## Inspection Report of 945 Fleming Way Stuart Florida 34997 Prepared for Dr Warren

# Inspection Report of 945 Fleming Way Stuart FL 34997 for Dr Warren 7.27.06

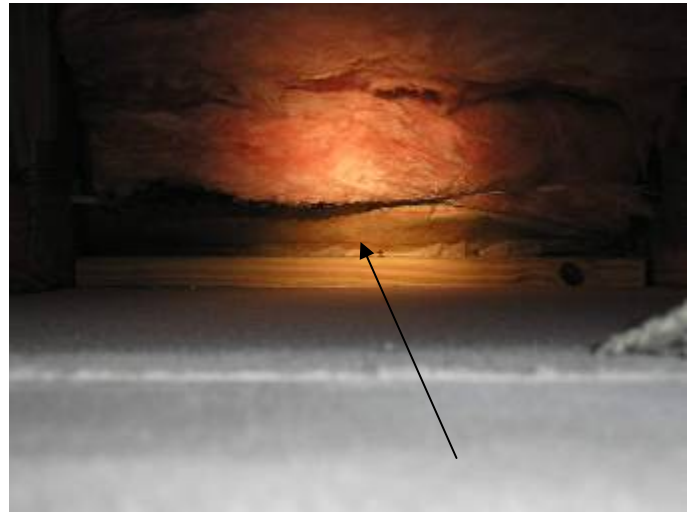
The ceiling joist (rat run) was not completely secured in the attic. §2306.2

The manufacturer states the paper facing is flammable & should not be exposed. §M304.1, §708.2

There is exposed kraft paper insulation backing in the attic. The manufacturer states the facing will burn & should not be exposed. §M304.1, §708.2

§708.2.1 Insulating materials, when concealed as installed, in buildings of any type construction, shall have a flame spread rating of not more than 75 and a smoke developed rating of not more than 450.

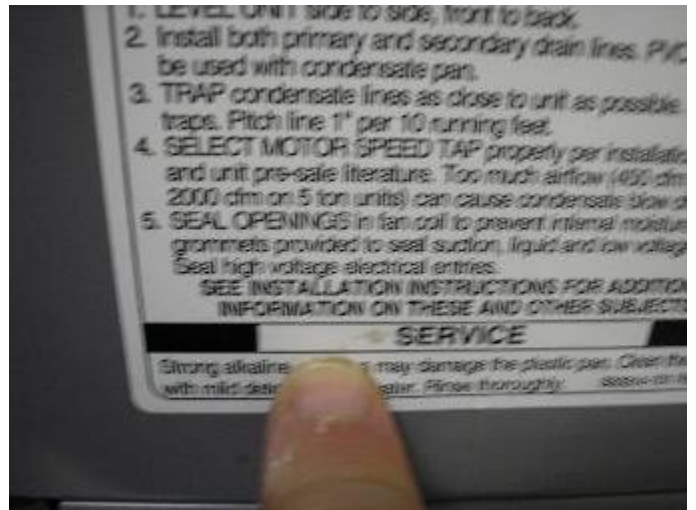
The range is installed with an electrical cord rated at 40 amps. The 50 amp overcurrent protection breaker in the main distribution panel is too big. §M304.1

The range is installed with an electrical cord rated at 40 amps. The 50 amp overcurrent protection breaker in the main distribution panel is too big.

Review the manufacturer's installation instructions.
